Addendum No. 1
March 9, 2021

Project: Jane Addams Elementary School – C.I.P. Addition And Renovations PD #3312
Project location: 2511 W. Brookings Street, Sioux Falls, SD 57104
Project number: 1105.2914.20

Architect: Architecture Incorporated

2.30

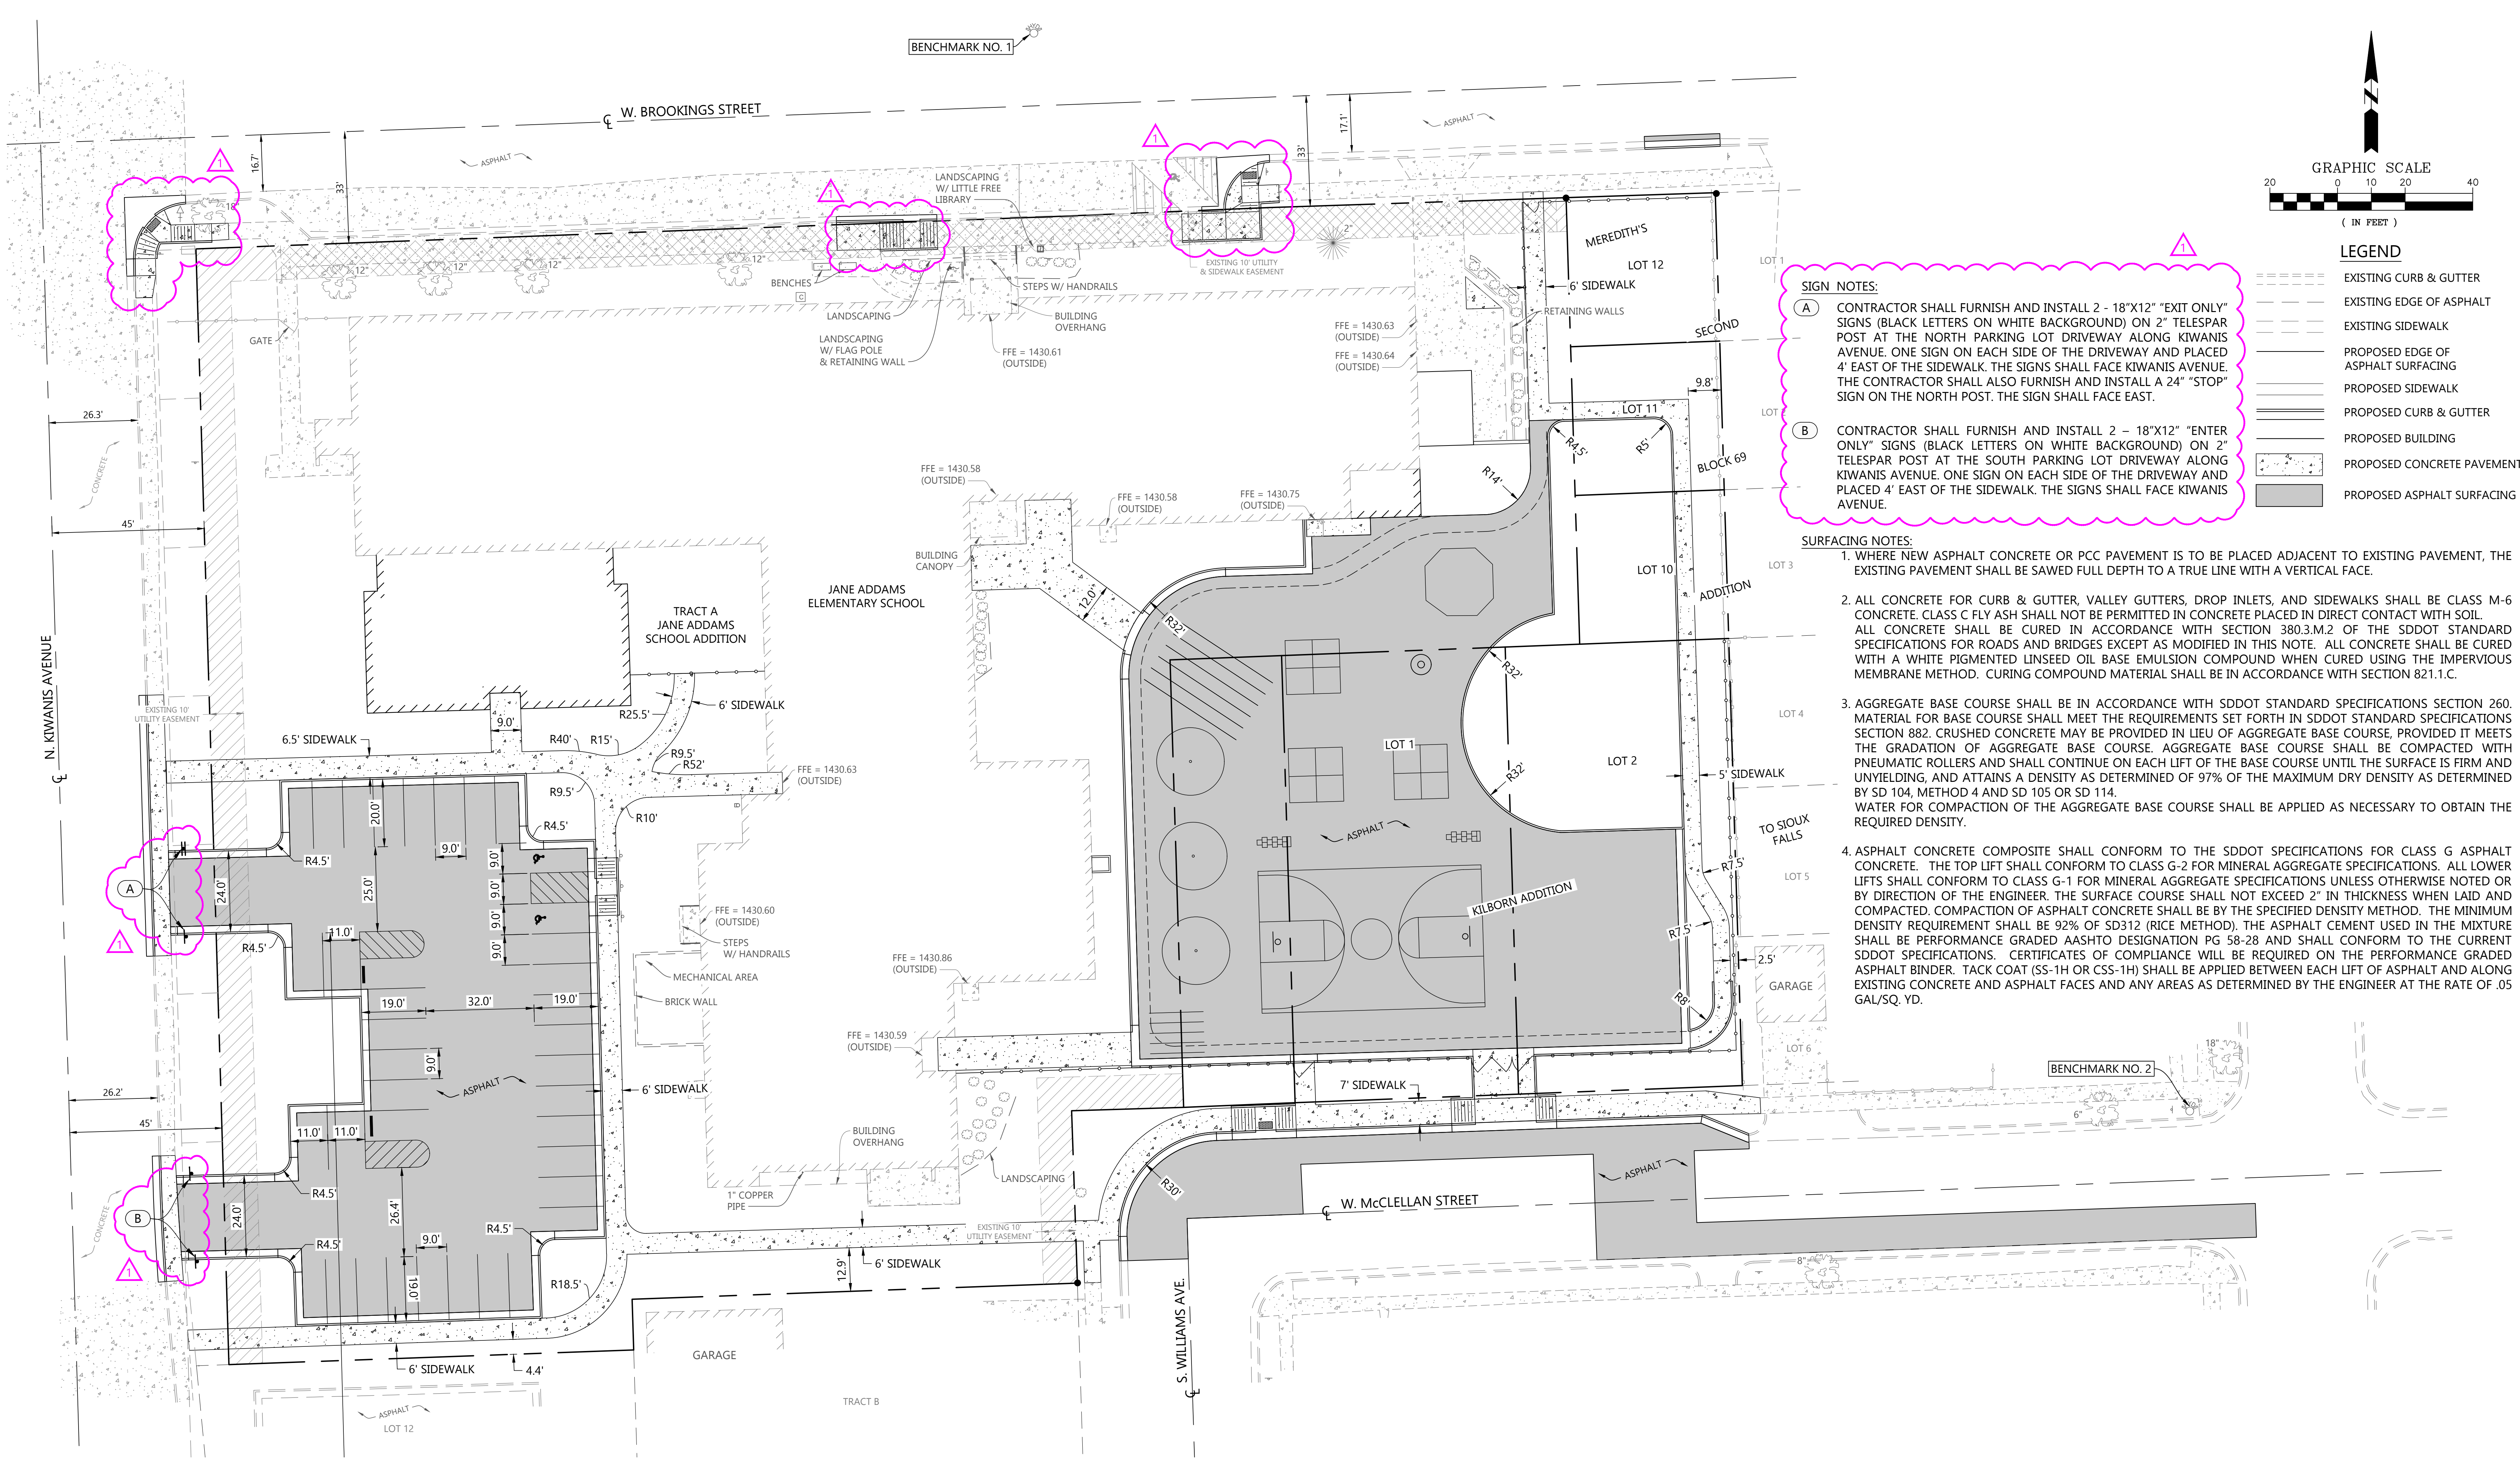
- c) Added a sign remove/salvage/reset to the eastern most ADA ramp along Brookings Street.
- 5) DRAWING 2.30 – CIVIL SITE PLAN:
- a) Signage notes were added to include permanent signage at parking lot driveways along Kiwanis Avenue.

- b) ADA improvement locations along Brookings Street were added.
- 6) DRAWING 2.43 CIVIL GRADING PLAN:
- a) This sheet was added to the plans and details the ADA ramp improvements along Brookings Street.

2.50

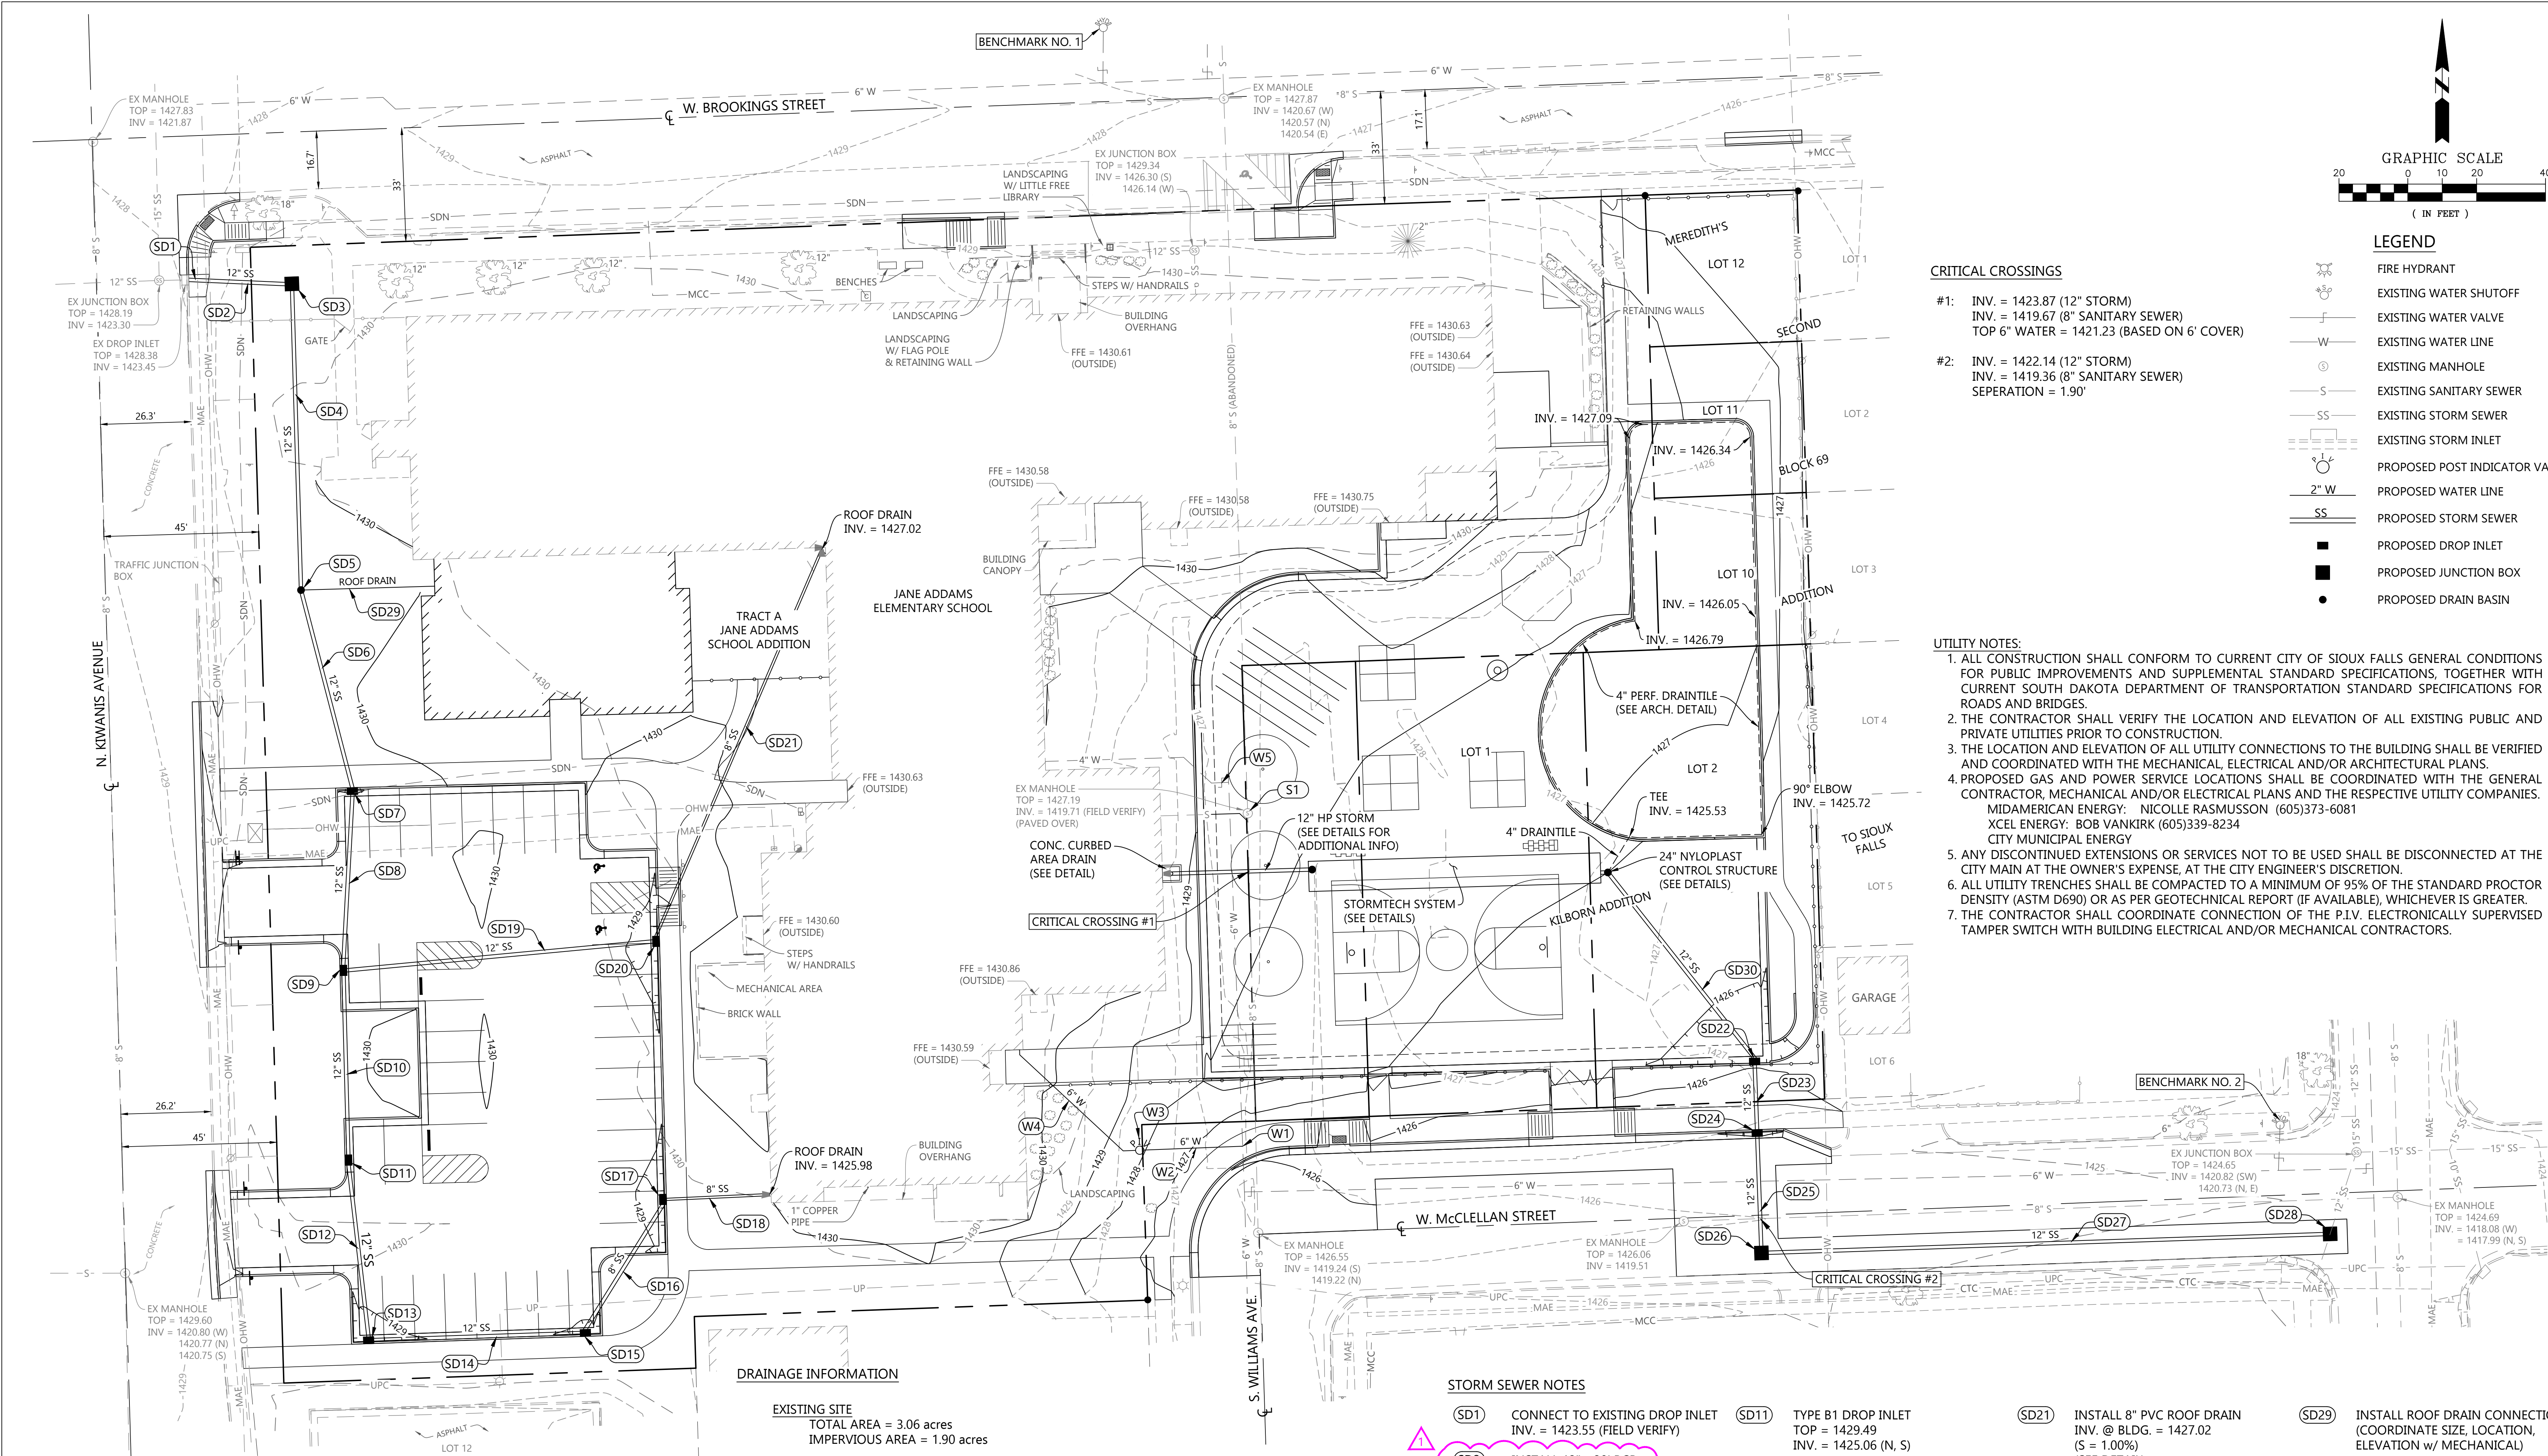
- 7) DRAWING 2.50 UTILITY/DRAINAGE PLAN:
- a) Storm callout SD2:
 - i) Pipe length was adjusted from 26' to 28'.
 - ii) Slope was adjusted.
 - b) Water Main Notes callouts W3 and W4:

- i) Added 6" MJ Restraining Devices that are required at valves and fittings.
 - ii) Utility demo callout #2 note should be changed from curb stop to corp stop.
